## CONSTRUCTION DOCUMENTS REVIEW

Revised  
Layout

RE: QUIZNOS SUB  
Airline Highway, Store #11445  
17524 Airline Highway, Suite 10  
Prairieville, LA 70769

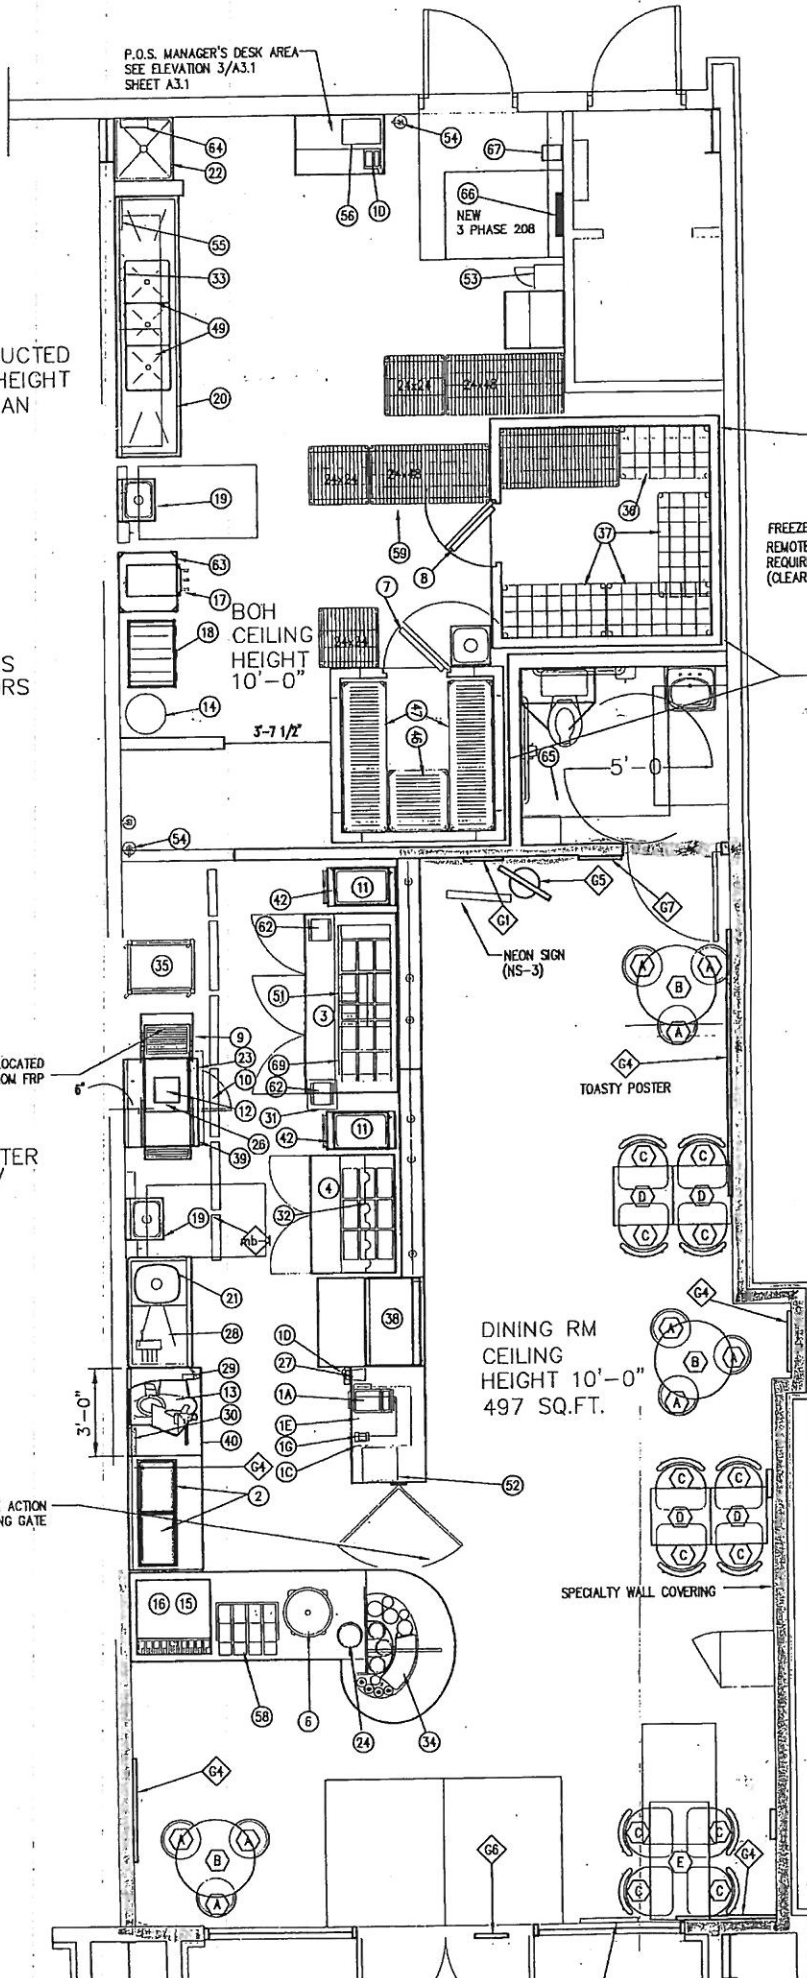
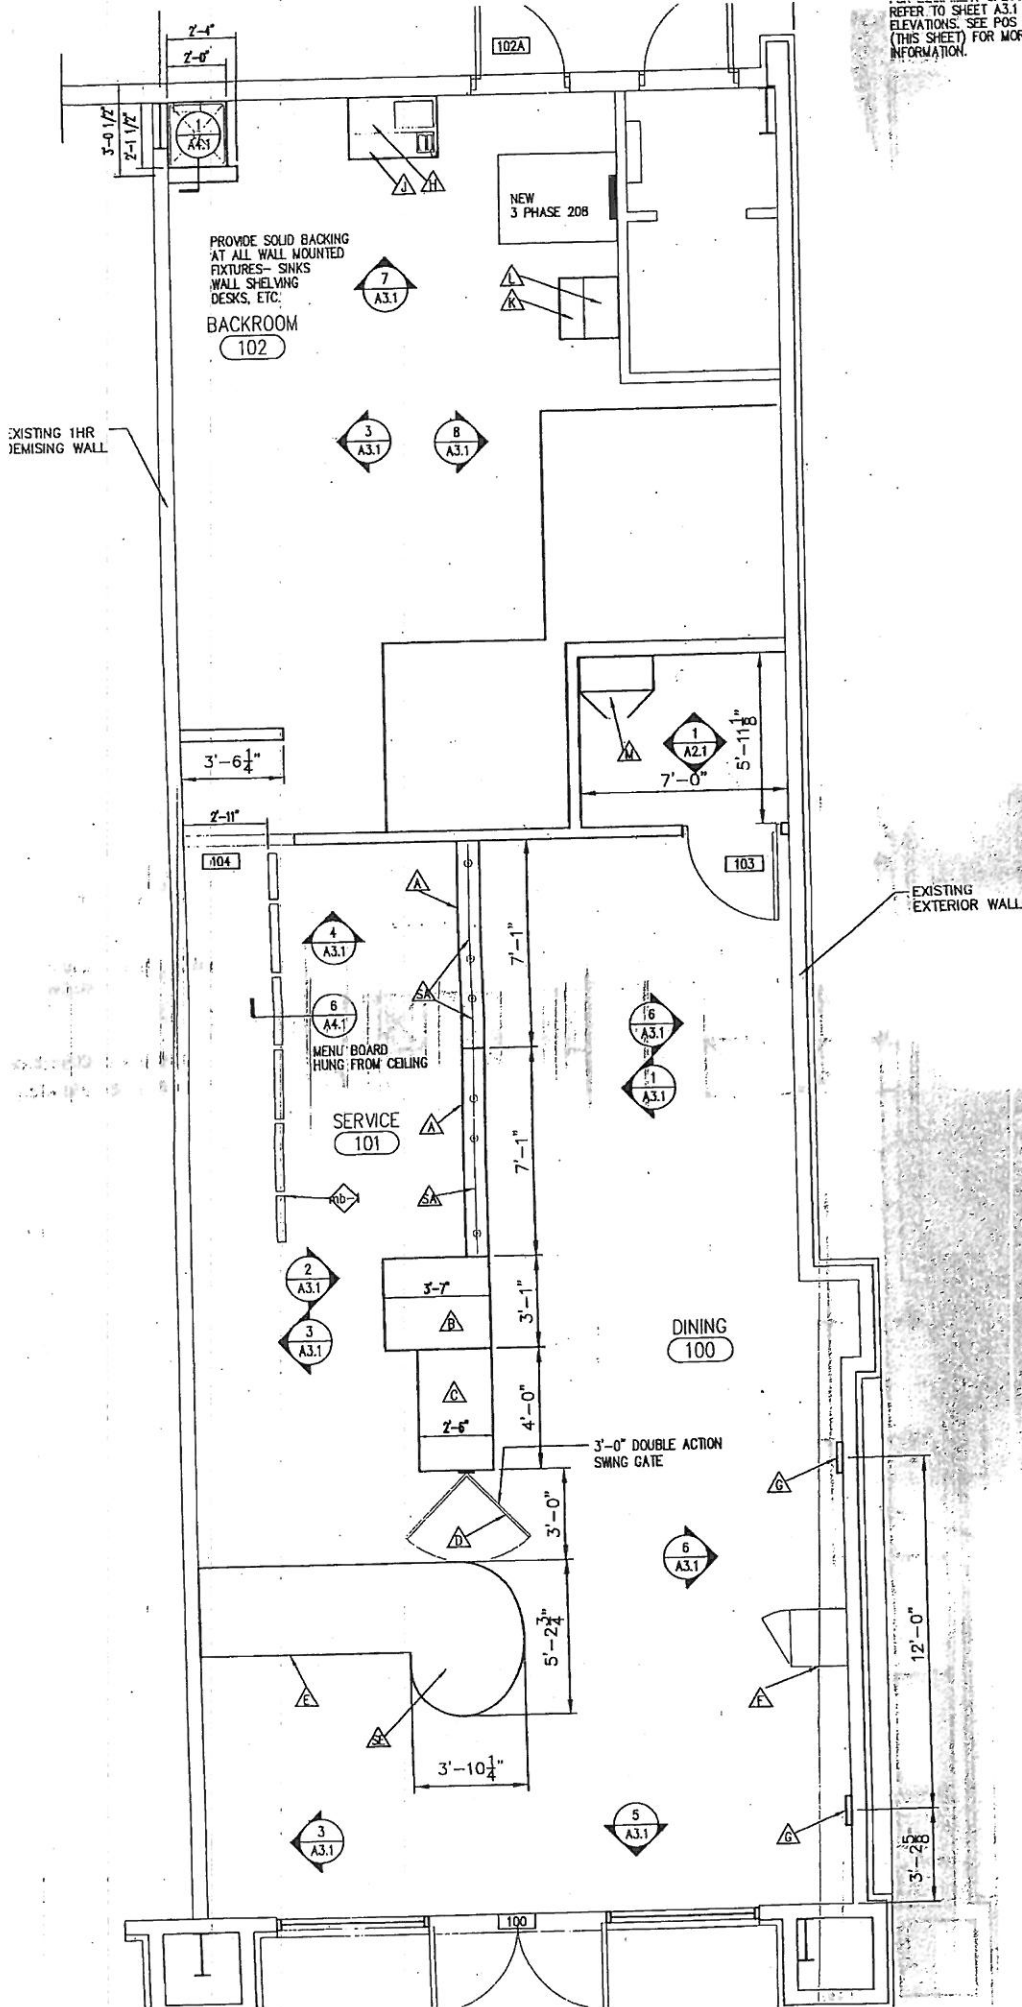
- c. **Refer to prototype for correct wall covering placement.** "V4" to be placed behind the "Toasty" poster (if applicable). Do not place wall covering of the same color side by side, alternate colors (V2, V3, V4 etc.).

- f. A 6x6x7'6 cooler, **Remote compressor,** will be ordered. **Verify.**
  - g. A **208V toaster will be ordered. Verify.**
  - h. **Effective immediately- Place the toaster oven 6" to 8" away from the FRP to prevent the FRP from melting due to high temperatures from the toaster oven.**

- i. **Verify clearance of service line due to toaster moving.**
  - j. **Verify two (2) 20-amp circuits are provided for the soup station.**

- k. All millwork will be ordered as standard prototype sizes.
- l. Note: all sneeze guard glass must be angled 15 degrees, VERIFY.
- m. The electrical panel has been noted as NEW, and will be ordered.
- (n)** Please show the FRP to the customer side of the beverage counter. See attached.

TOASTER MUST BE LOCATED  
6" TO 8" AWAY FROM FRP

TOASTER  
208V
